**Subject:** [FI] S.16 Application No. A/YL-SK/371 - FI to address departemntal comments

**2<sup>nd</sup> Further Information**

**(S.16 Planning Application No. A/YL-SK/371)**

**Responses-to-Comments**

- NOTES :**
1. ALL DIMENSIONS ARE IN MILLIMETRES UNLESS OTHERWISE STATED.
  2. ALL LEVELS ARE IN mPD METRE ABOVE HONG KONG PRINCIPAL DATUM.

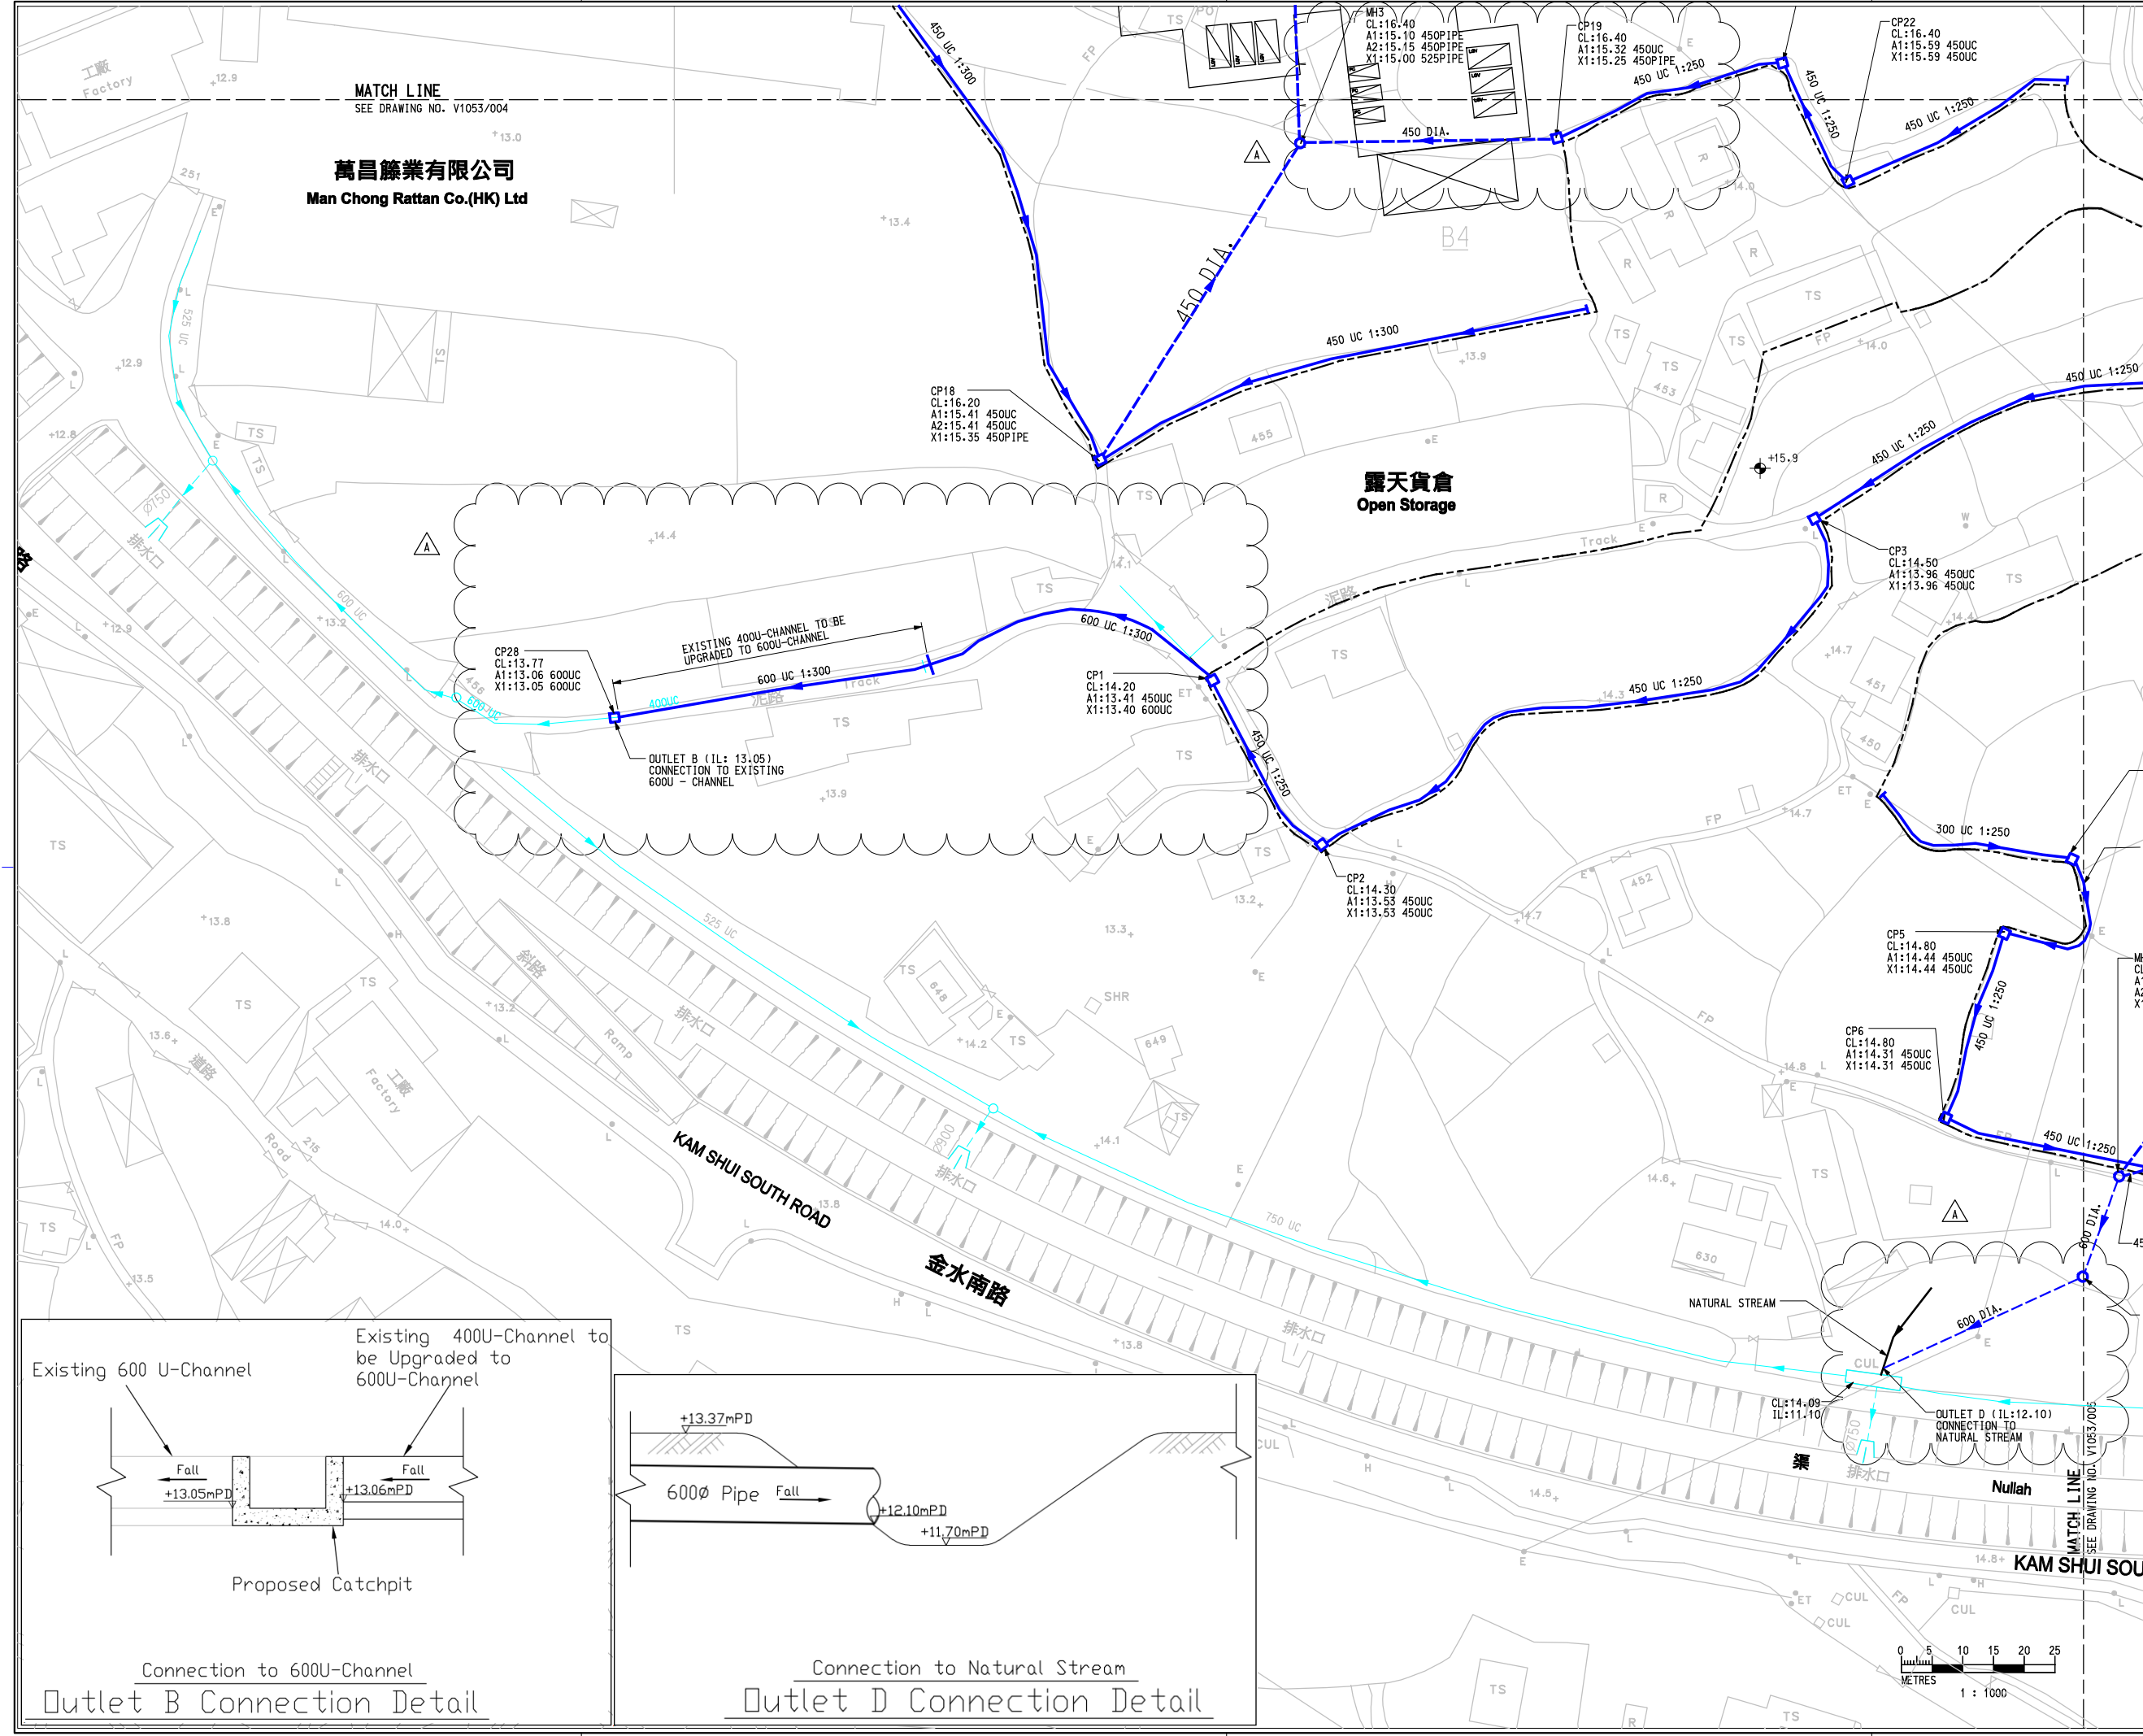
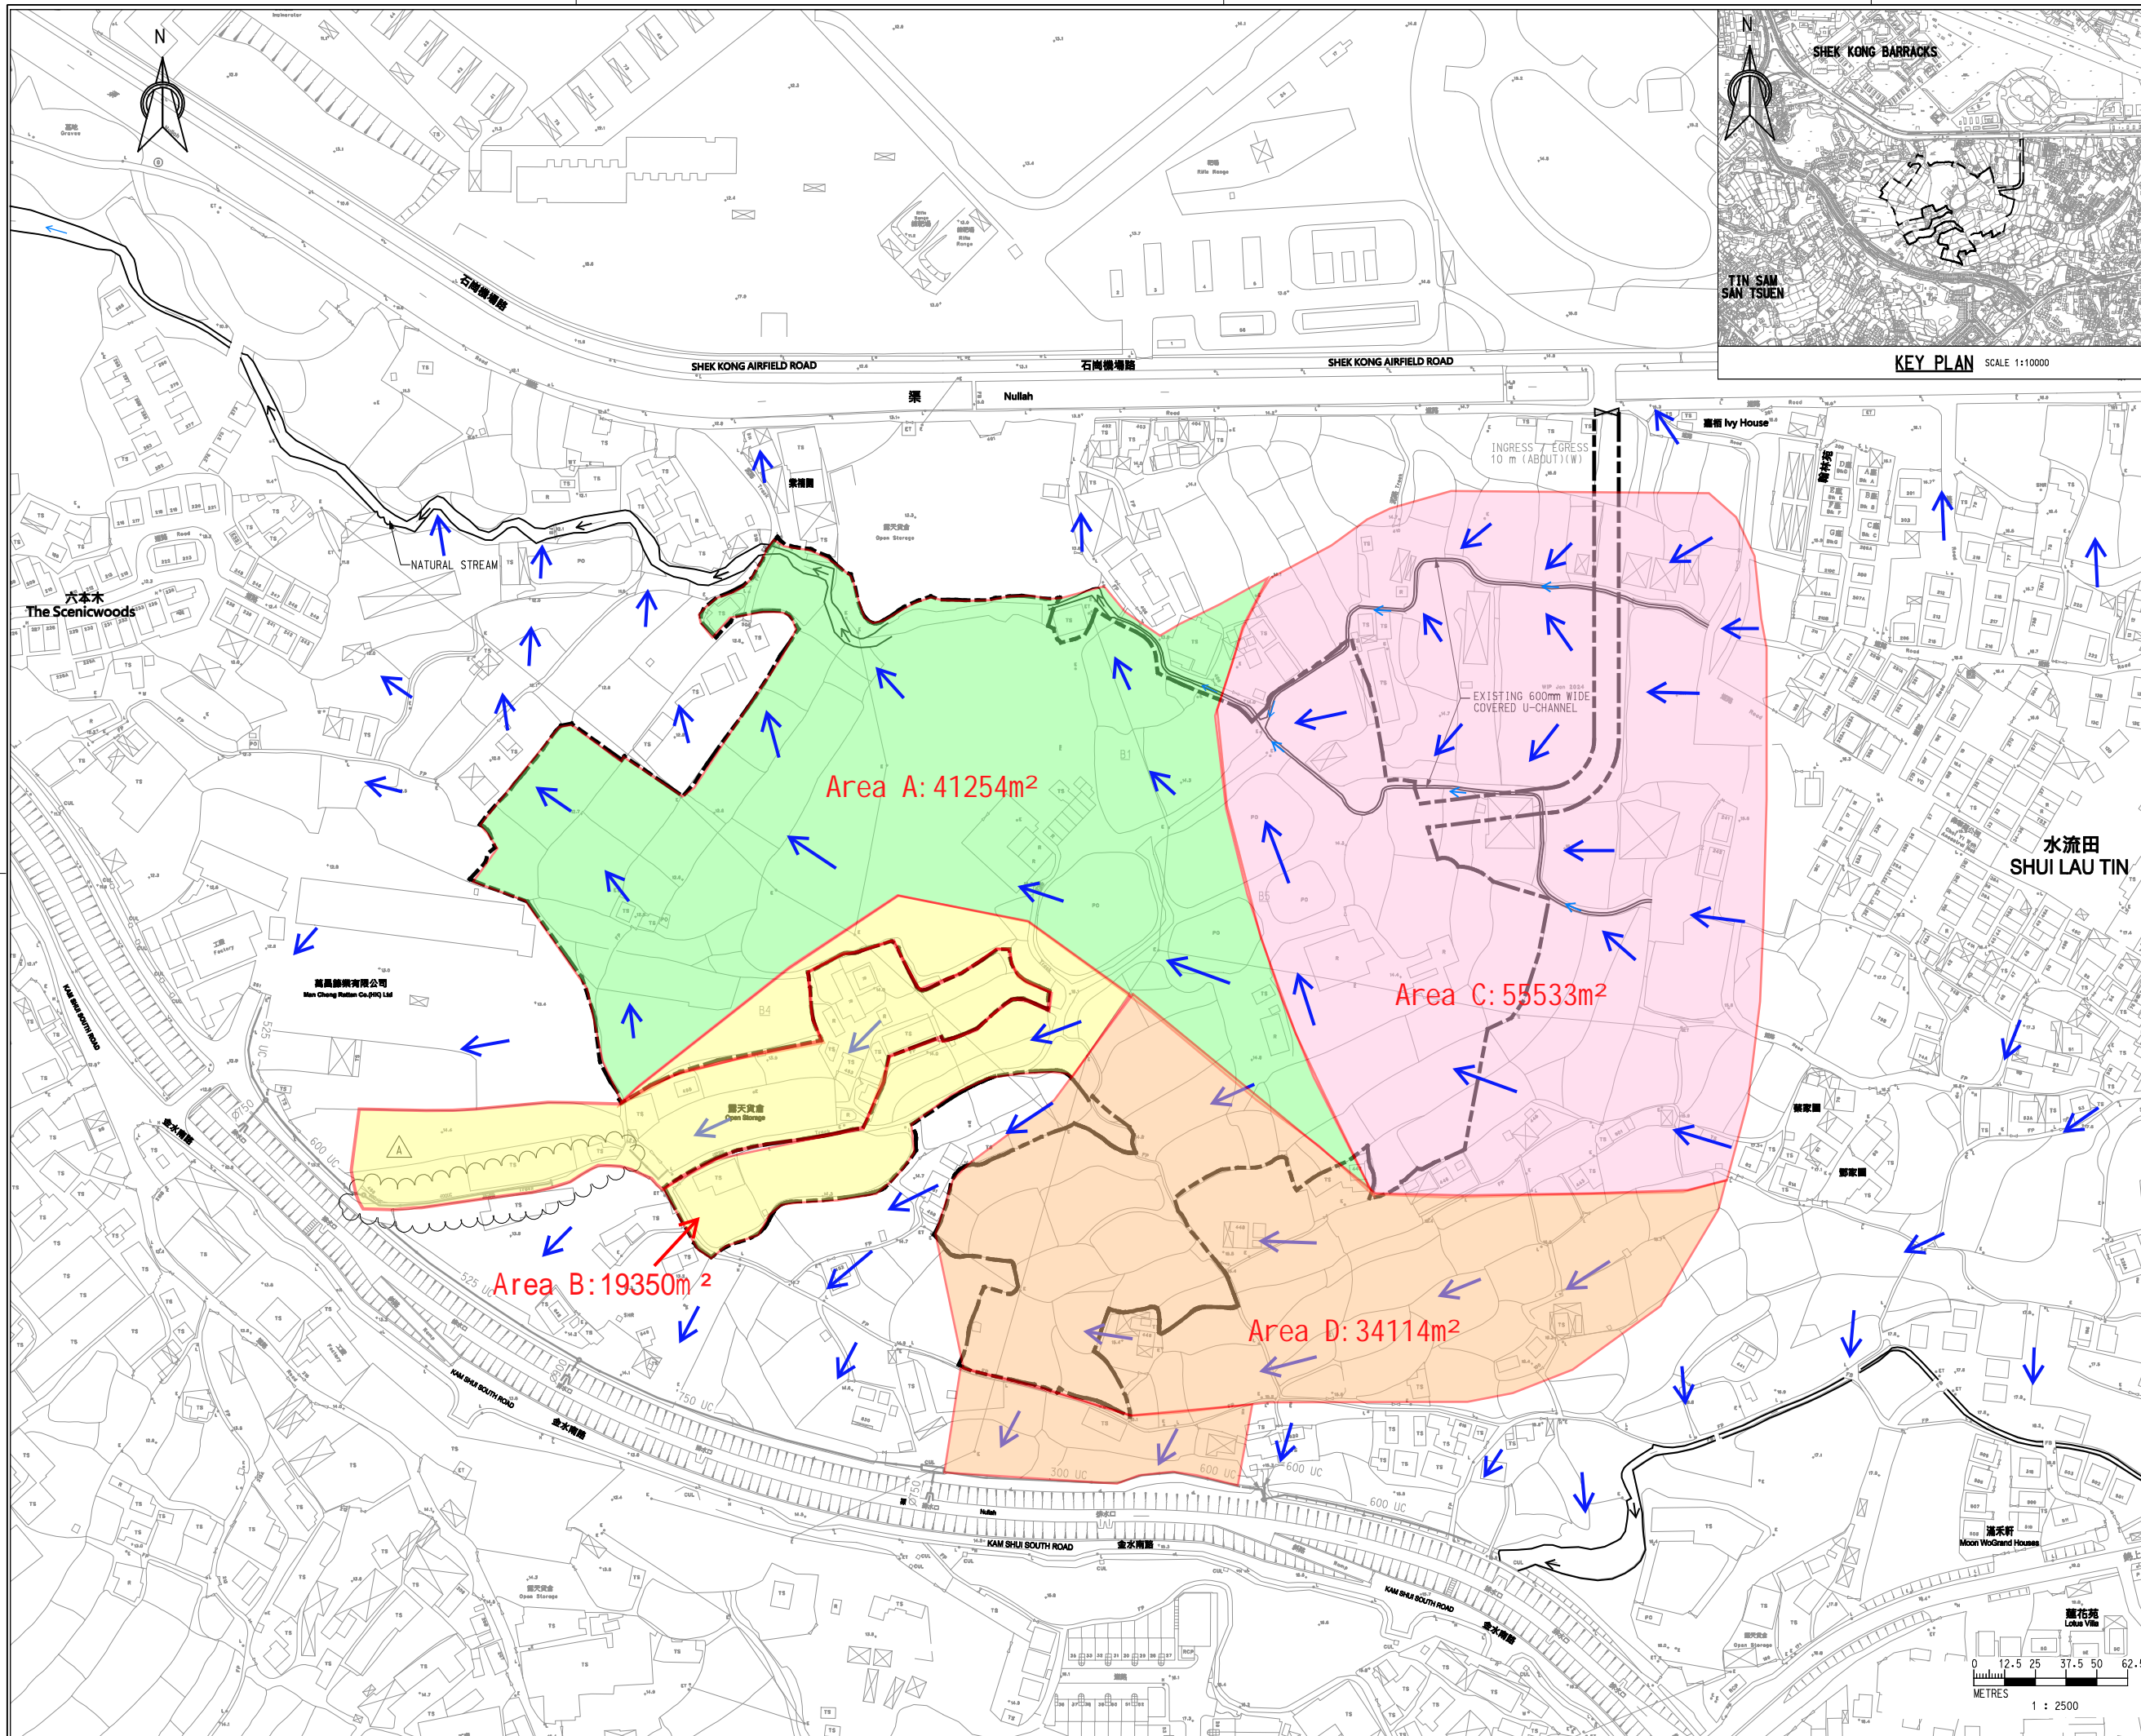
(b)	Please show the construction details as all discharge point and indicate all C.L., I.L and catchpit/streamcourse bottom level in the drawing.	Noted. The connection details at all discharge points are shown on Drawing No. V1053/003A~006A in Appendix A.

Drawing No.	Stage	Rev.
<b>V1053/010</b>	<b>P</b>	<b>A</b>

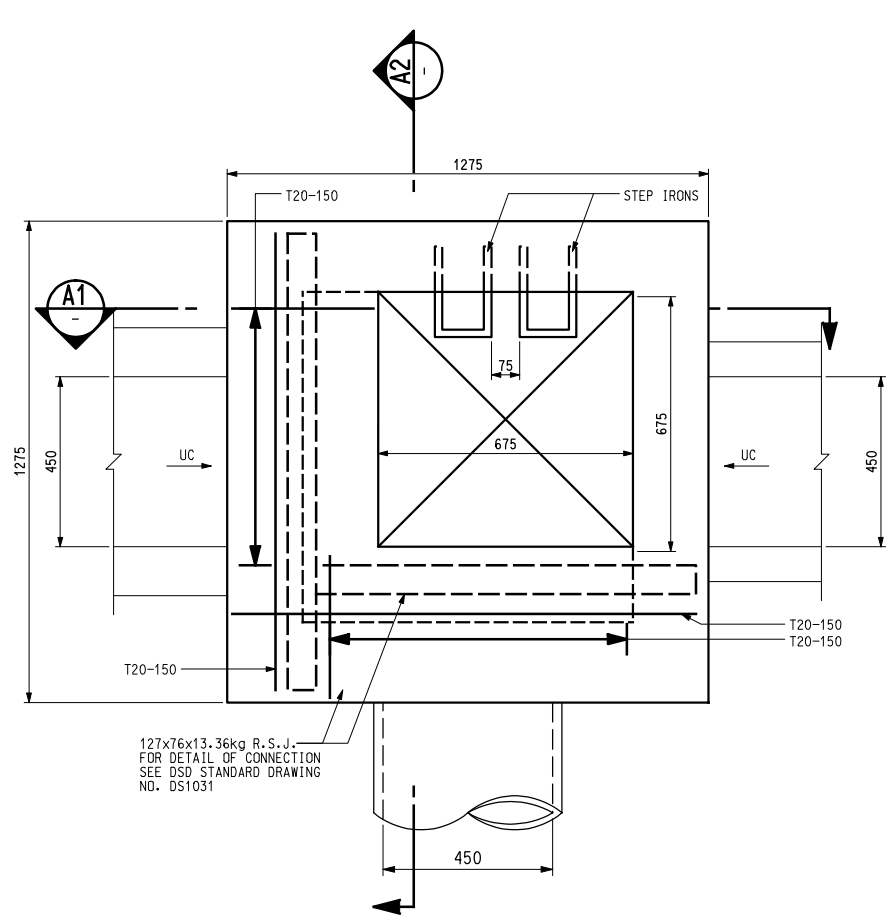
- 3.5 The catchment plan after upon completion of the proposed development is demonstrated on the **Drawing No. V1053/010A** in **Appendix A**. The surface runoff within the Site's area will be collected by the proposed drainage systems and to be discharged into the existing drains. The drainage layout plans are shown on the **Drawing Nos. V1053/003A to 006A** in **Appendix A**.
